**1958 Agreement – Consideration of draft amendments
to existing Regulations submitted by GRE**

Proposal for Supplement 1 to the original version of Regulation No. [128] (Light Emitting Diode (LED) light sources)

Submitted by the Working Party on Lighting and Light Signalling*

Figure 1
Main Drawing – front and side view

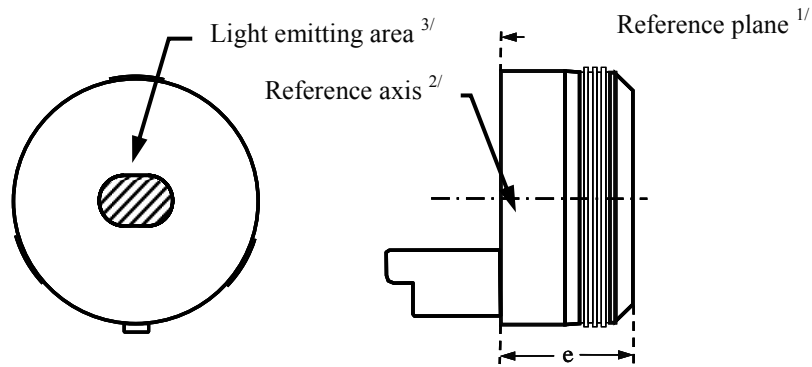
Insert new sheets LW2/1 to 5 , to read (see next pages):

The drawings are intended only to illustrate the essential dimensions (in mm) of the LED light source

Figure 3

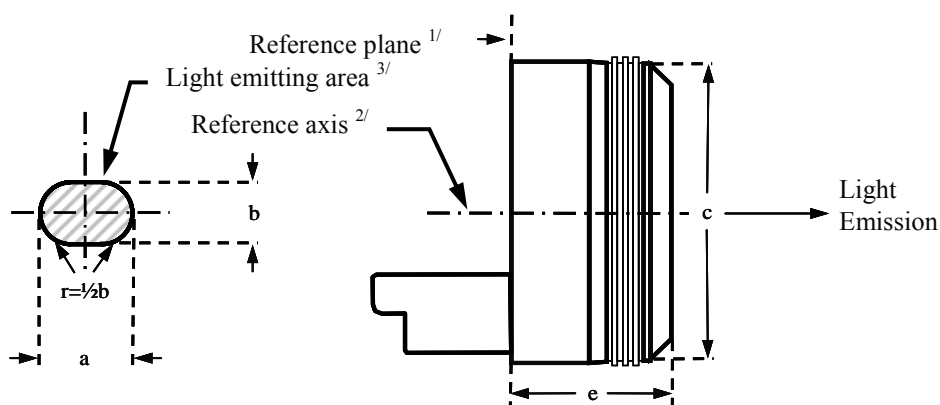
Compliance of position and dimension as defined in Table 2 is checked by the box system shown in Figure 3. The left drawing displays the projection when viewing along the reference axis with an aperture acceptance angle of $\pm 40^\circ$ while the right drawing defines the position of the reference plane and axis.

This test is intended to determine whether the light emitting area of the LED light source is correctly positioned relative to the reference axis and reference plane.

Size determination shall be done with suitable means.

Figure 4

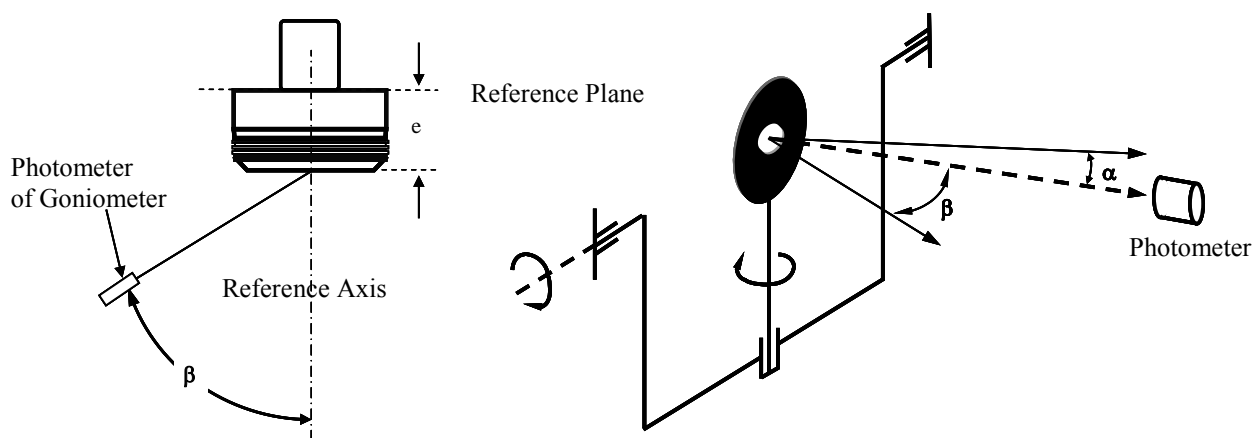
The light source is mounted on a flat plate with the corresponding mounting lug features. The plate is mounted to the goniometer table by a bracket in such way, that the reference axis of the light source lines up with the measurement axis of the goniometer. The corresponding measurement set-up is described in Figure 4.

Goniophotometers of type I or II according to CIE publication No. 70 -1987 with the capability of turning the light source around two axes perpendicular to the axis of light emission can be used. The intersection of the reference axis and the parallel plane to the reference plane in distance e is used as the coordinate system origin.

Figure 5
Rear-view: thermal contact area and location of T_b -point on the vertical symmetry axis, at a distance f from the center

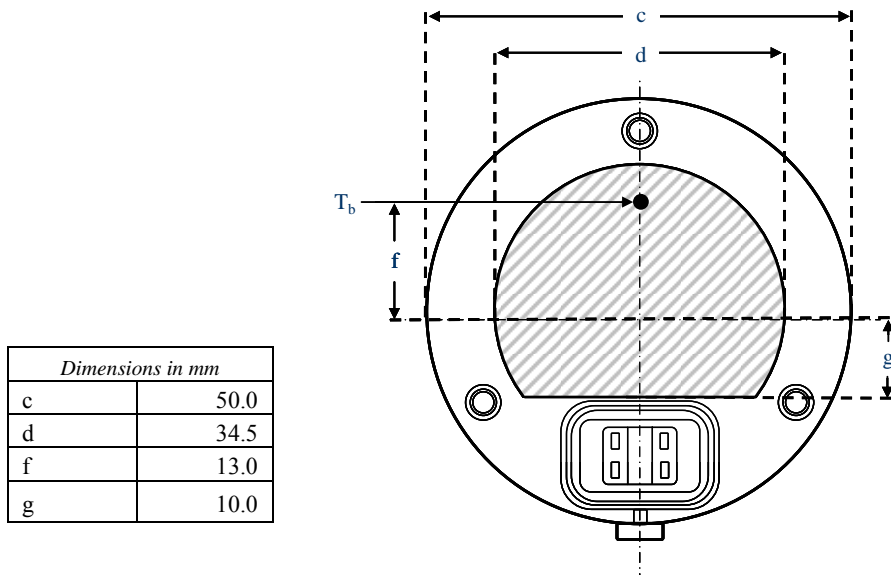
The LW2 thermal interface is located within the reference plane (shaded area in Figure 5) and described in detail in IEC Publication 60061 as indicated in Table 1 on sheet LW2/1. It shall be attached to an appropriate heat sink or thermal management system.

The luminous flux given in Table 1 shall be achieved once the base temperature T_b measured at the location shown in Figure 5 is stabilized.

Data shall be recorded for the specified base temperature T_b from Table 1 at the location shown in Fig. 5.
